**RE: Response to GRCA Comments**  
**Capital Paving Inc. – Montrose Pit**  
**Part of Lots 71, 74 & 75 Concession G.C.T**  
**Township of Woolwich, Region of Waterloo**

**RE: Technical Response  
Grand River Conservation Authority Letter dated June 25, 2009  
Capital Paving Inc. Proposed Montrose Pit.**

**Reference: Capital Paving Inc., Montrose Pit  
Part of Lots 71, 74 & 75, Concession G.C.T.  
Township of Woolwich, Region of Waterloo  
GRCA Letter to Capital Paving (June 25, 2009)  
Stantec Consulting Ltd. Technical Response**

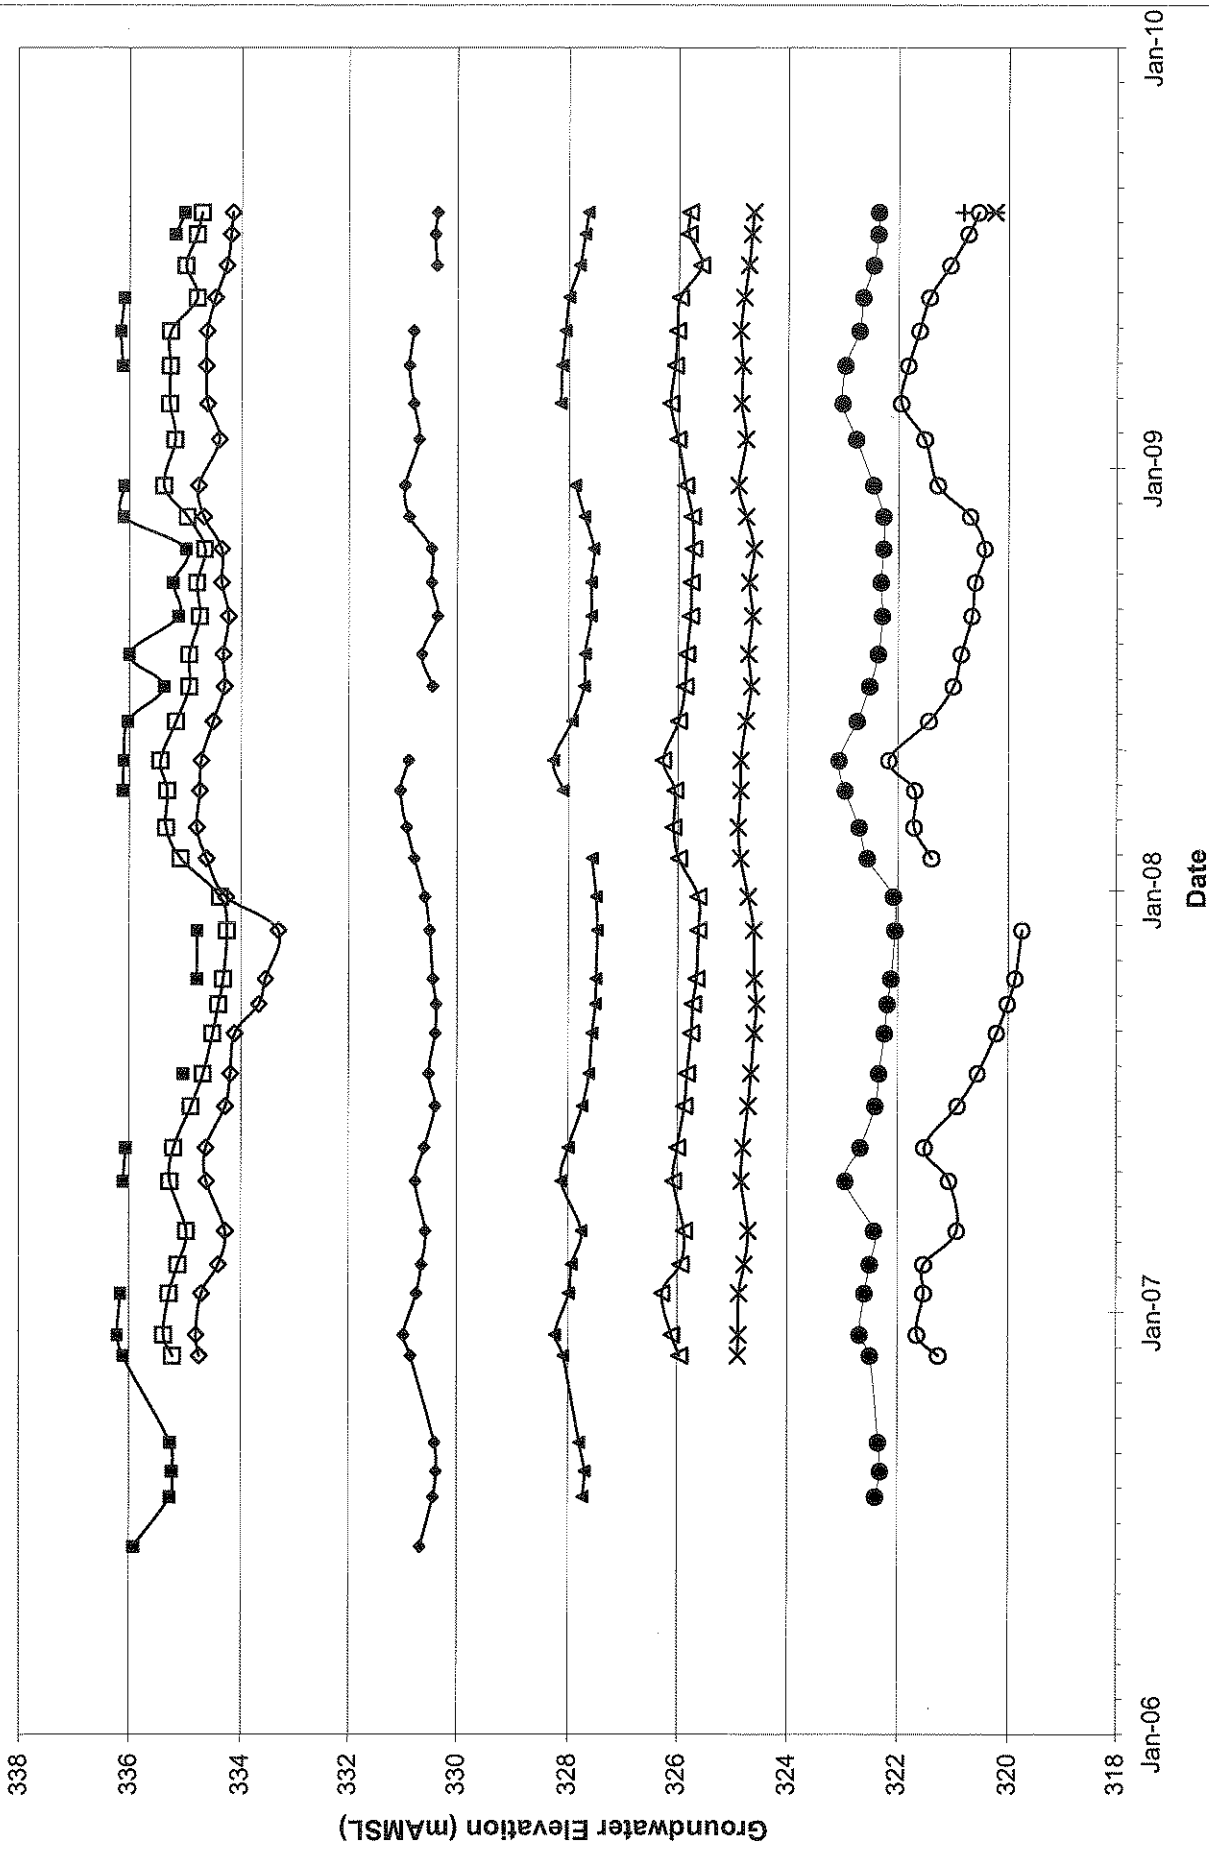
An updated monitoring summary is attached to this letter for reference. The Established Groundwater Table at the site for the purposes of the Site Plan was developed in accordance with Ministry of Natural Resources (MNR) Policy. The Established Groundwater Table for the Site Plan is based on the observed December 2006 water table elevations at 9 monitoring well and drive-point piezometer locations distributed across the site. The December 2006 measurements correspond to a time of seasonal high based on the over 1.5 years of monitoring data available at that time. Subsequent monitoring has confirmed that Established Groundwater Table elevation is appropriate as the basis for the extraction and rehabilitation plan.

For example, at locations BH2, BH4, BH8, DP1, DP2 and DP2 the December 2006 levels are either the highest observed to date or within 6 cm of the highest levels observed to date. At BH6 the December 2006 level has only been exceeded 3 times (out of 34 measurements) and by a maximum of 18 cm. Location BH7 is at the proposed below water table extraction area, and although the water level at this location has been observed to be higher on occasion than measured in December 2006, this does not affect the Site Plan significantly. In addition, although the water level at DP4 has also been observed to occasionally be higher than measured in December 2006, the ground surface at DP4 is proposed to be raised as part of the rehabilitation plan.

With respect to pond volume calculations, in the projection (Stantec February 2009) the assumed water table elevation at the pond was 321.7 mAMSL. This level was exceeded at BH7 for a short period in April 2008 due to the extreme wet conditions at that time (as reflected in the January 23, 2009 memo). The conditions shown in the memo represent a short-lived extreme situation that was used for illustrative purposes as part of the groundwater impact assessment regarding wetlands. The monitoring summary included with this letter indicates that the groundwater level have not "continued to rise" since that time, but have fluctuated within a normal range. For the majority of the monitoring period water levels at BH7 are well below 321.7 mAMSL. Stantec will provide additional comment regarding pond storage capacity.
